ARCHITECT'S SUPPLEMENTAL INSTRUCTIONS

PROJECT:	Roosevelt Lofts Historic Rehabilitation San Angelo, TX	Report No.	Five (5)
OWNER:	Overland Property Group 234 N. Santa Fe Ave, Suite A Salina, KS 67401	Date	June 5, 2024
CONTRACTOR:	MCP Group 3501 SW Fairlawn Rd. Topeka, KS 66614	Architect's Proj No.	22-3281
		Contract For:	General Construction Mechanical, Electrical

DESCRIPTION:

COPPER PIPE SIZE INDICATED	ALTERNATE MATERIAL/SIZE	
	Cross-linked polyethylene (PEX)	Polypropylene (PP)
1/2"	3/4"	1/2"
3/4"	1"	1"
1"		1-1/4"
1-1/4"		1-1/2"
1-1/2"		2"
2"		2-1/2"
2-1/2"		3"
3"		3-1/2"

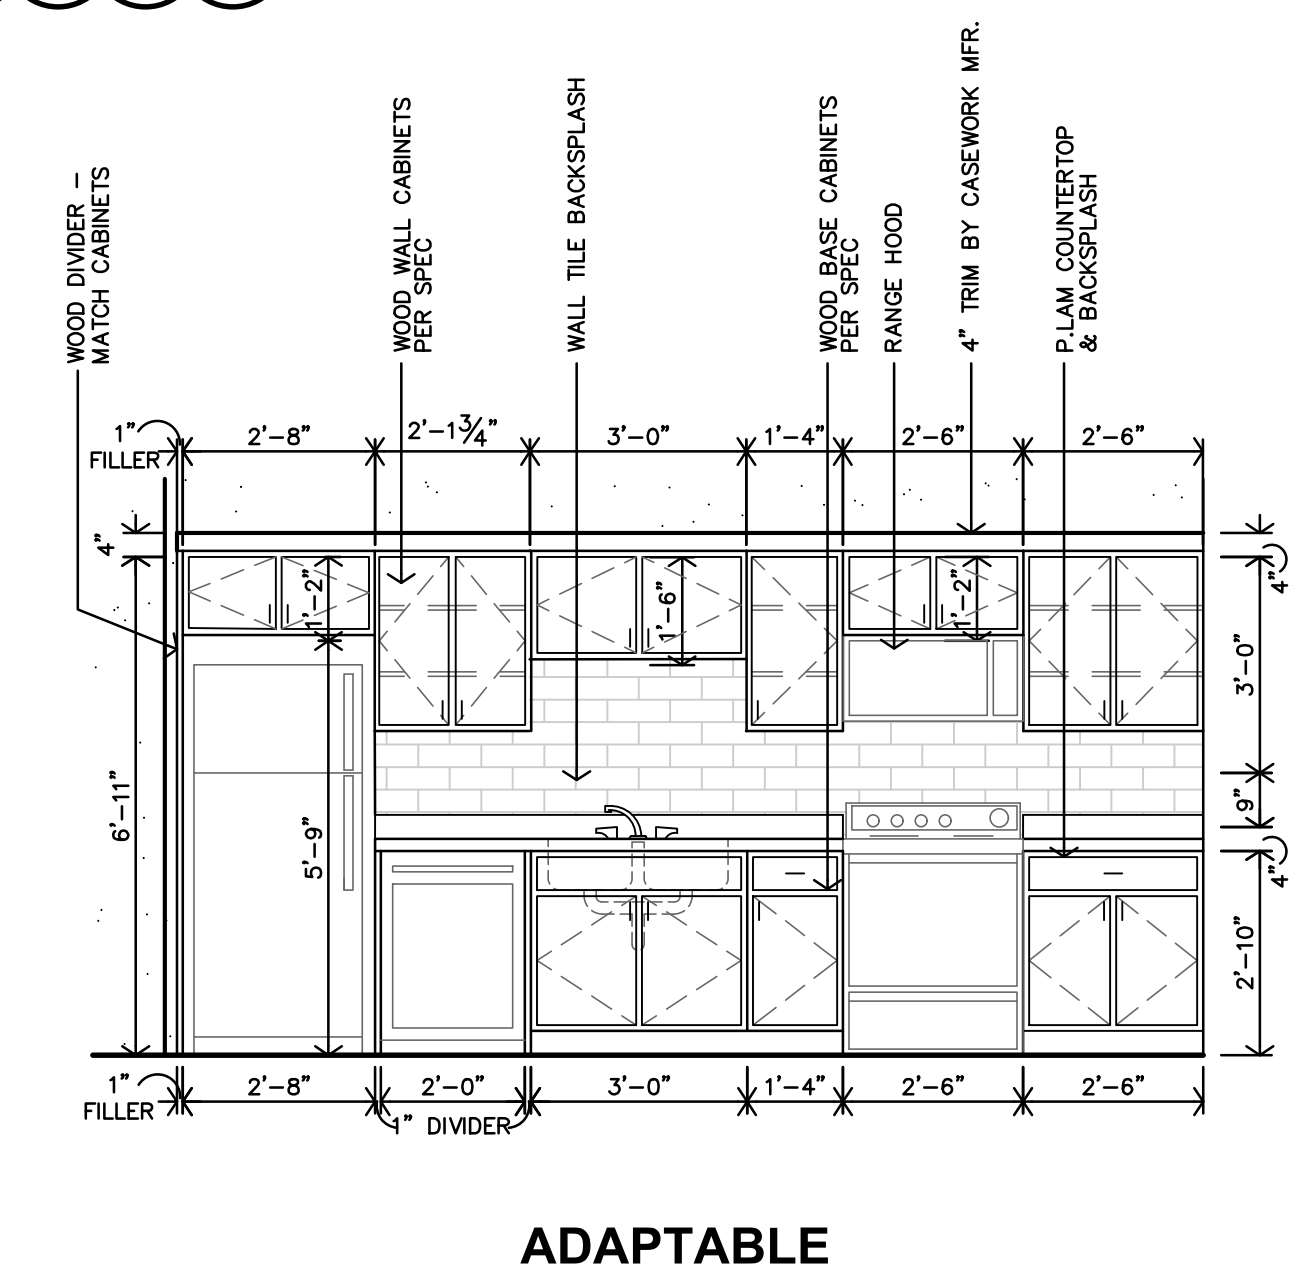
2. Apartment 13 (Rm #207) – Kitchen casework, fixtures, appliances, closet & shelves have been arranged to avoid a conflict between the entry door clearances and the refrigerator. Reference revised sheets A2.5, A9.5, A7.2, M1.9, E1.3, E1.10

3. Apartment 21 (Rm #307) - Kitchen casework, fixtures, appliances, closet & shelves have been arranged to avoid a conflict between the entry door clearances and the refrigerator. Reference revised sheets A2.7, A9.5, A7.2, M1.9, E1.3, E1.12

1 FIRST FLOOR DOMESTIC WATER PLAN
 1/8" = 1'-0"

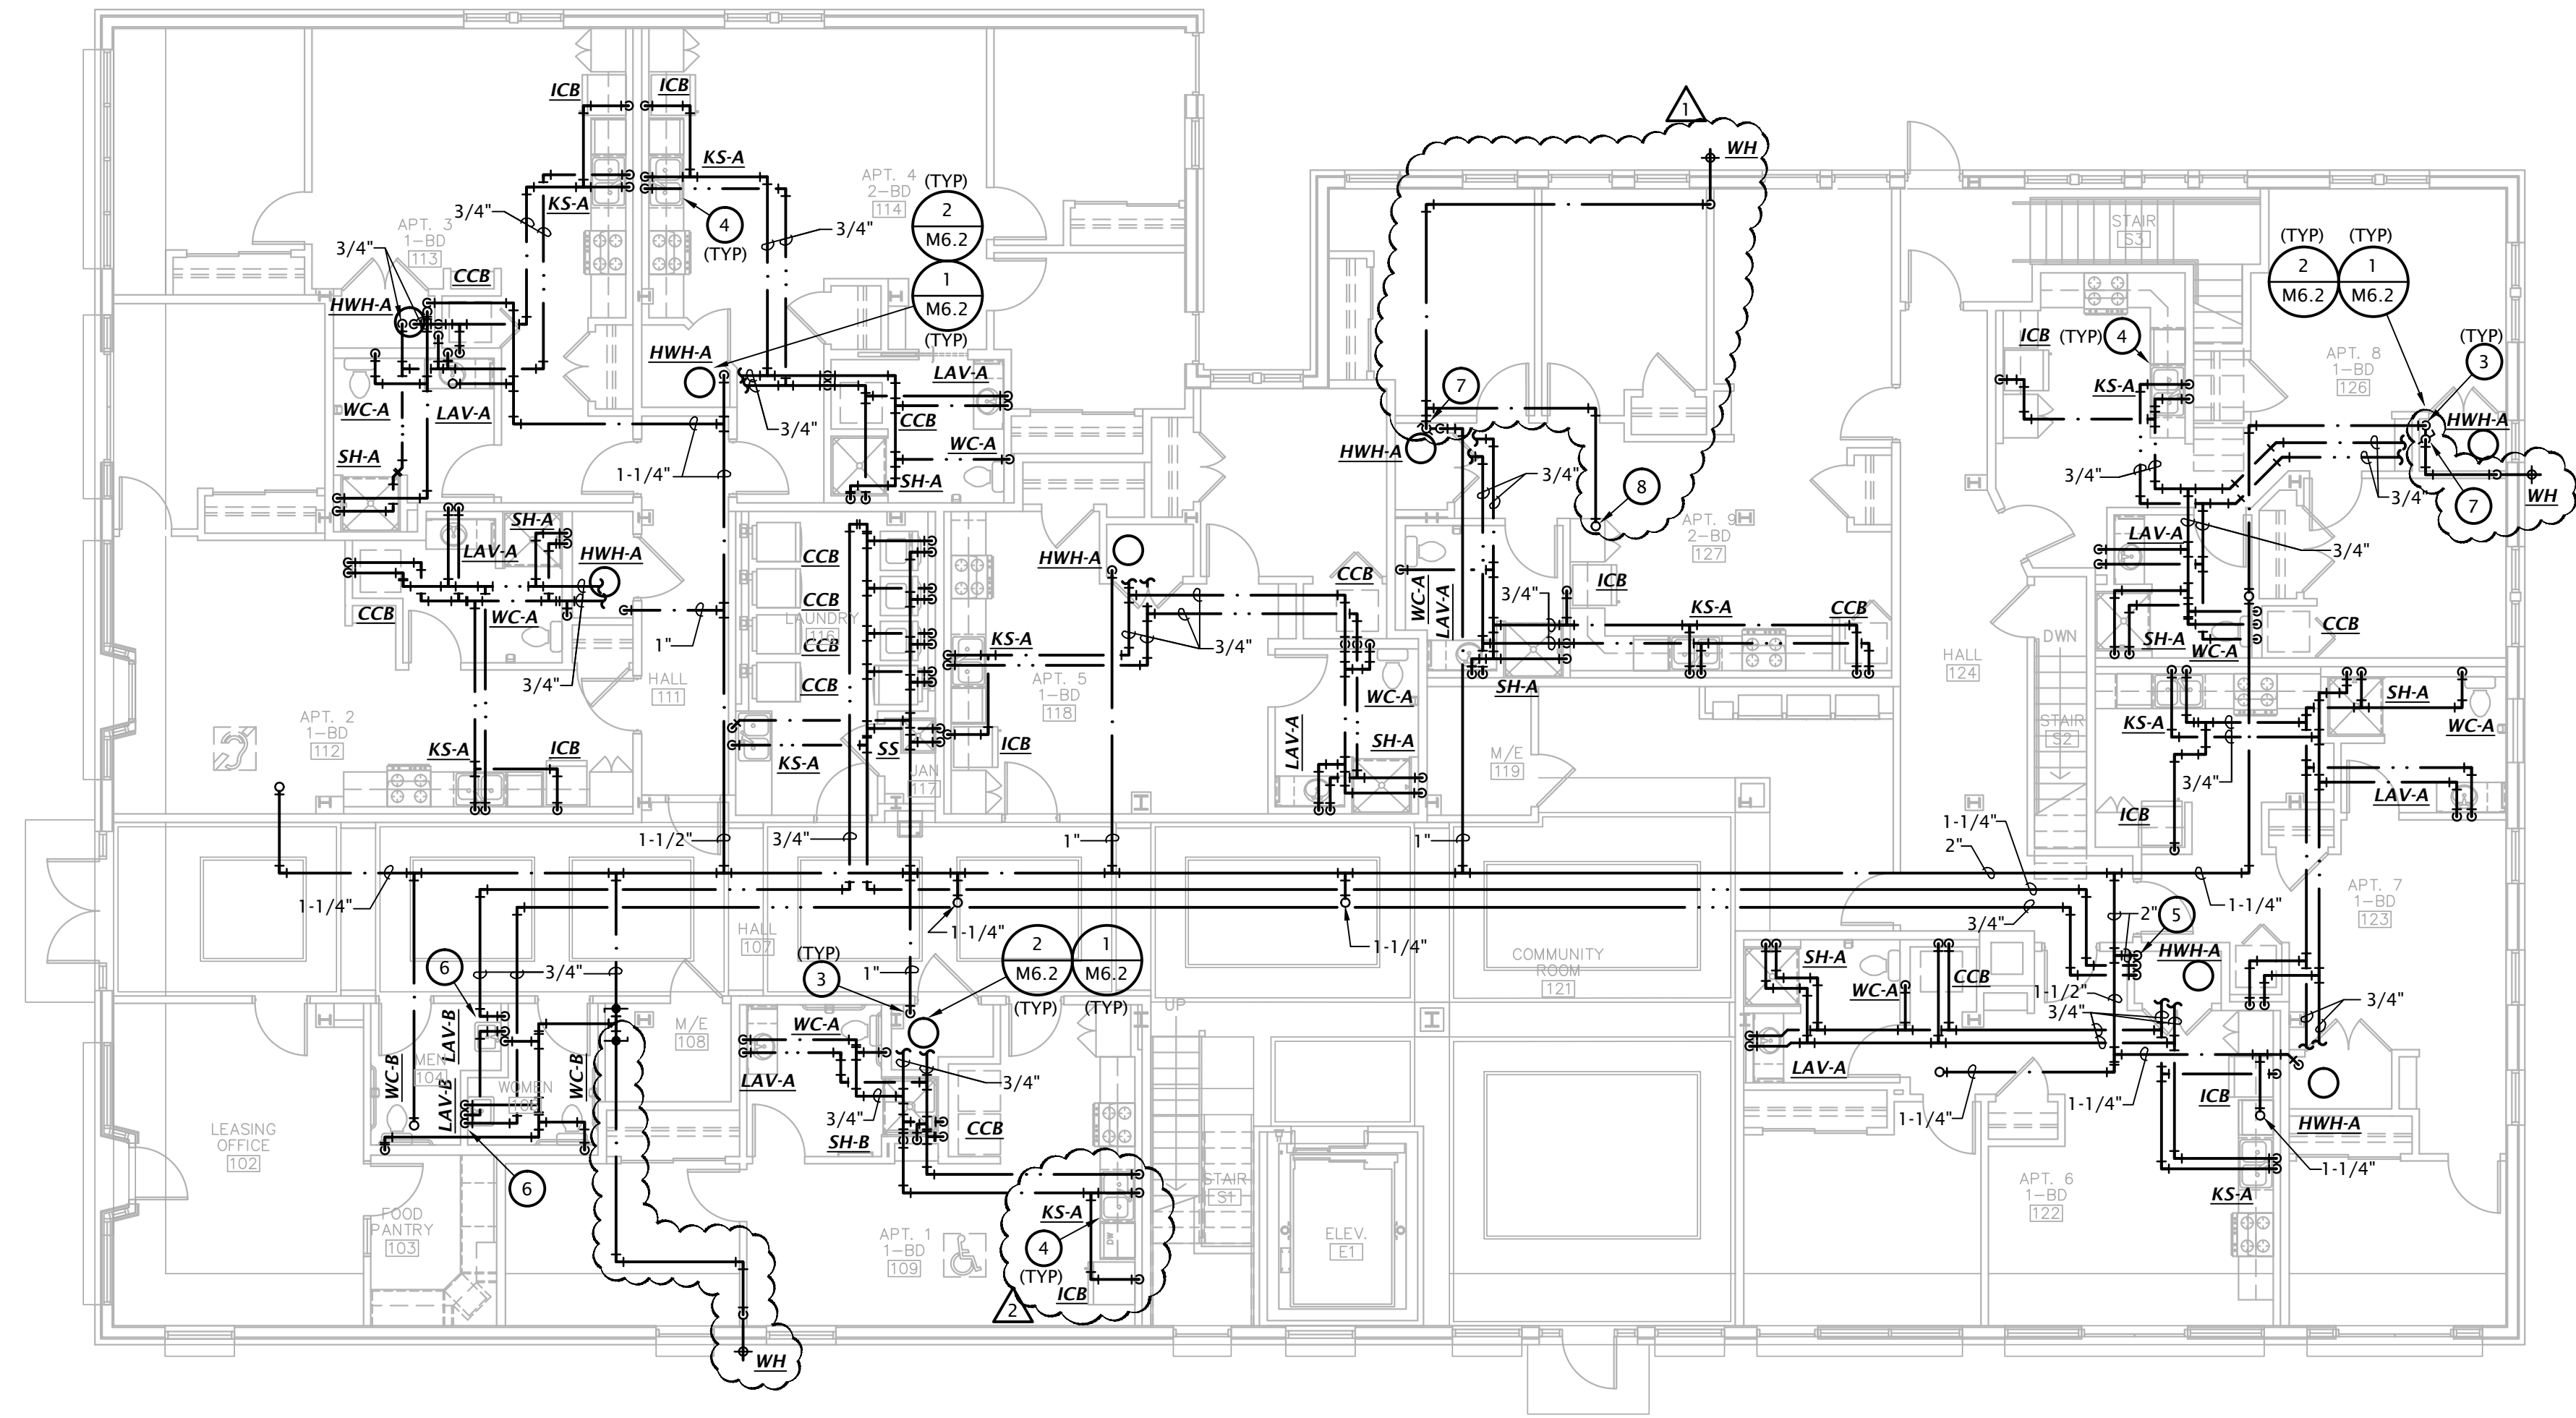
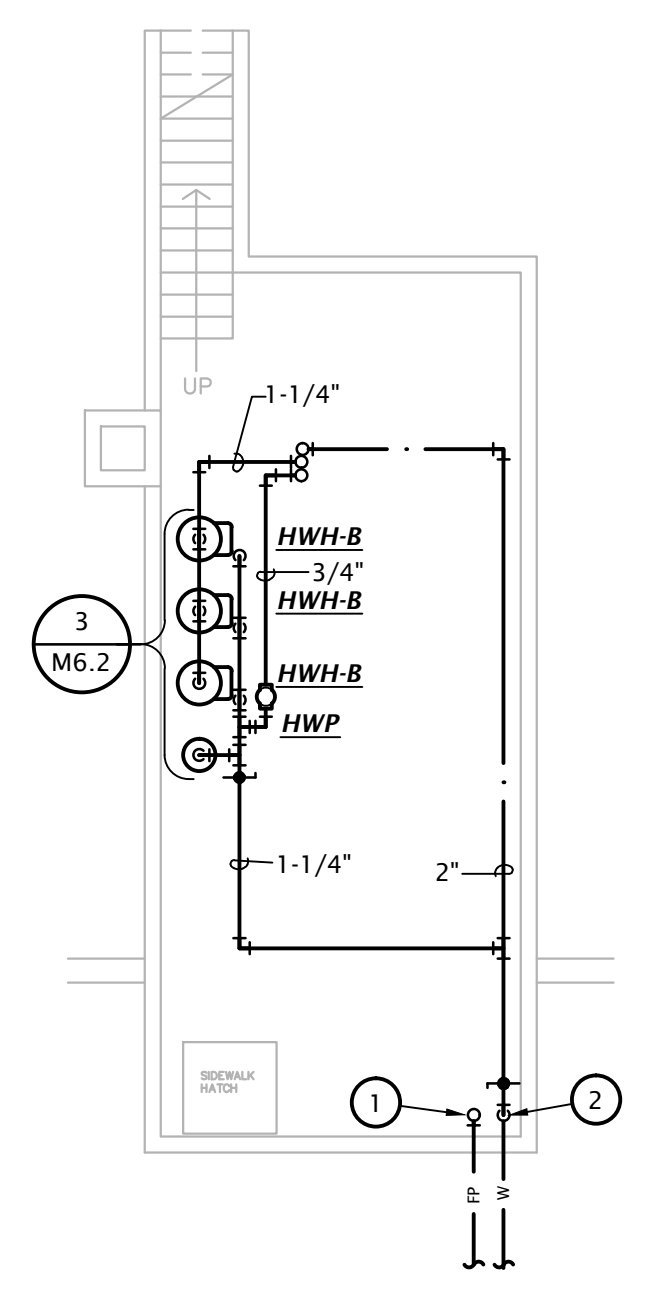
1. Apartment 1 (Rm #109) – Kitchen casework, fixtures and appliances have been rearranged to avoid a conflict between the entry door clearances and the refrigerator. Reference revised sheets A2.3, A-A9.5, M1.8, E1.1
